LIFT STATIONS REHABILITATION - PHASE 5
Solicitation Number: CO-00483
Job No.: 16-2502

ADDENDUM 1
November 12, 2021

LIFT STATIONS REHABILITATION - PHASE 5
TYPICAL ELECTRICAL RACK DETAIL

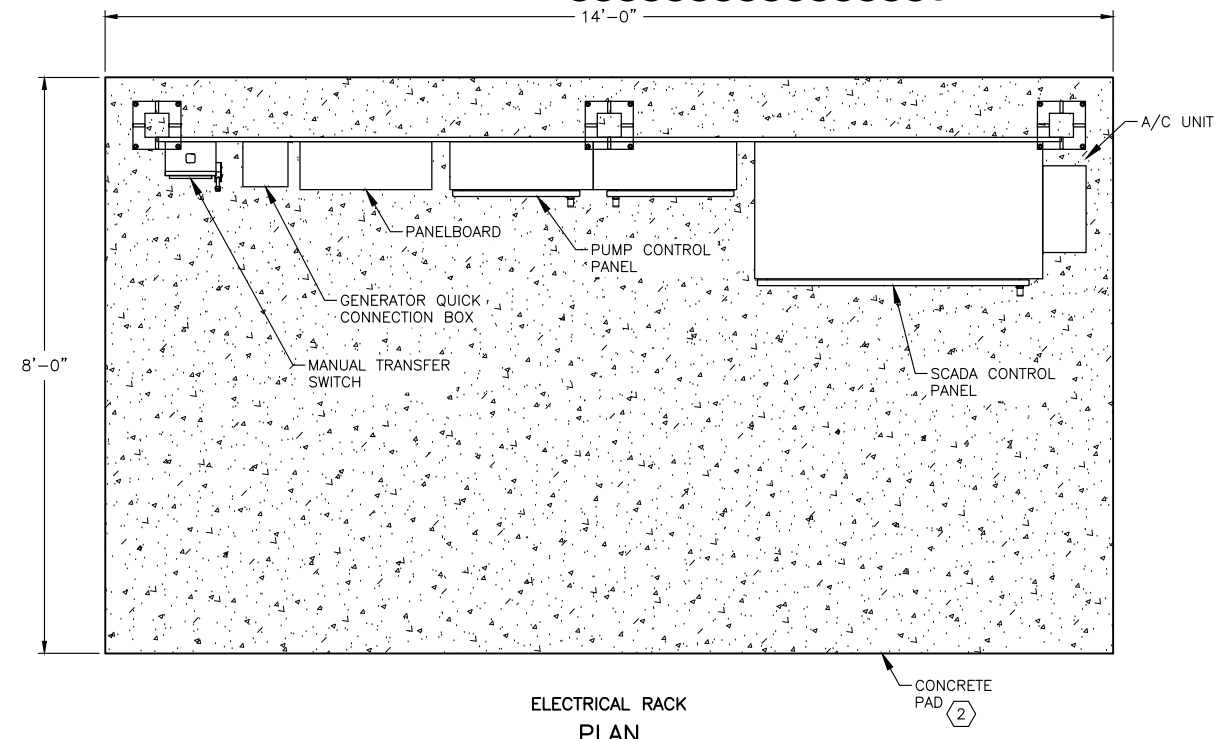
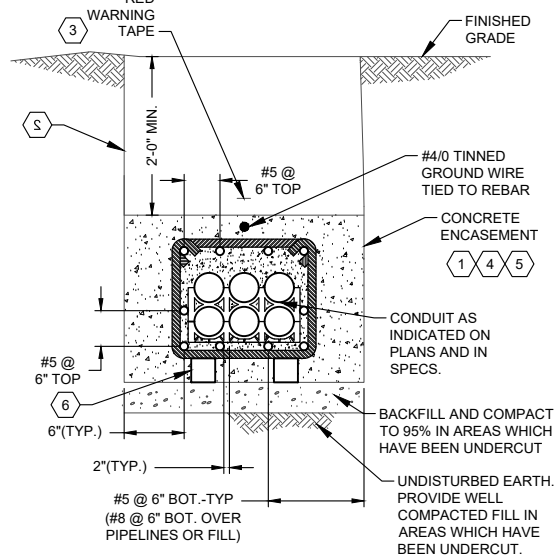
1. **Question:** Is there a design for the electrical canopies (sheet 140)?

Response: Yes, basic layout is shown on sheet 140, but contractor shall provide the following:

1. Contractor shall be responsible for designing the equipment rack/canopy and the equipment rack/canopy foundation for all lift stations requiring equipment rack/canopy and/or rack/canopy foundation. Contractor shall be required to have a Professional Structural Engineer licensed in the State of Texas design the foundation for the equipment rack/canopy and rack/canopy foundation, costs associated with the rack/canopy and rack/canopy foundation design and installation shall be included in the base bid.
2. All structural members of canopy shall be welded.
3. Install gutters to drain storm water.
4. Canopy structure shall withstand winds of up to 115 mph (ultimate).

- GENERAL NOTES:**
- CONTRACTOR IS RESPONSIBLE FOR DESIGNING THE EQUIPMENT RACK/CANOPY AND THE EQUIPMENT RACK/CANOPY FOUNDATION FOR ALL LIFT STATIONS REQUIRING AN EQUIPMENT RACK/CANOPY AND/OR A RACK FOUNDATION. CONTRACTOR WILL BE REQUIRED TO HAVE A PROFESSIONAL STRUCTURAL ENGINEER REGISTERED IN THE STATE OF TEXAS DESIGN THE FOUNDATION FOR THE EQUIPMENT RACK/CANOPY AND RACK FOUNDATION, COSTS ASSOCIATED WITH THE RACK/CANOPY AND RACK/CANOPY FOUNDATION DESIGN AND INSTALLATION SHALL BE INCLUDED IN THE BASE BID.
 - ALL STRUCTURAL MEMBERS OF CANOPY SHALL BE SOLIDLY WELDED.
 - INSTALL GUTTERS TO DRAIN STORM WATER.
 - CANOPY STRUCTURE SHALL WITHSTAND WINDS OF UP TO 115 MPH. (ULTIMATE)

DETAIL E02
LIGHTING STANDARD BASE
NTS

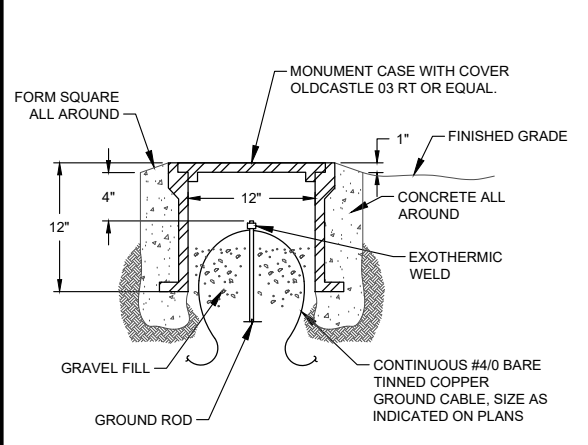
2. **Question:** Detail E-02 on sheet 141 says to refer to structural drawings for the light pole base piers. The structural drawings do not show any pier design.

Response: Contractor shall be responsible for designing the light pole foundations for all lift stations requiring area light. Contractor shall be required to have a Professional Structural Engineer licensed in the State of Texas design the foundation for the pole light, and costs associated with the foundation design shall be included in the base bid. Contractor shall refer to changes/revisions on Sheet E-5 (141 of 150).

1. CONTRACTOR IS RESPONSIBLE FOR DESIGNING THE LIGHT POLE FOUNDATIONS FOR ALL LIFT STATIONS REQUIRING AN AREA LIGHT. CONTRACTOR WILL BE REQUIRED TO HAVE A PROFESSIONAL STRUCTURAL ENGINEER REGISTERED IN THE STATE OF TEXAS DESIGN THE FOUNDATION FOR THE POLE LIGHT AT EACH SITE REQUIRED. COSTS ASSOCIATED WITH THE FOUNDATION DESIGN SHALL BE INCLUDED IN THE BASE BID.
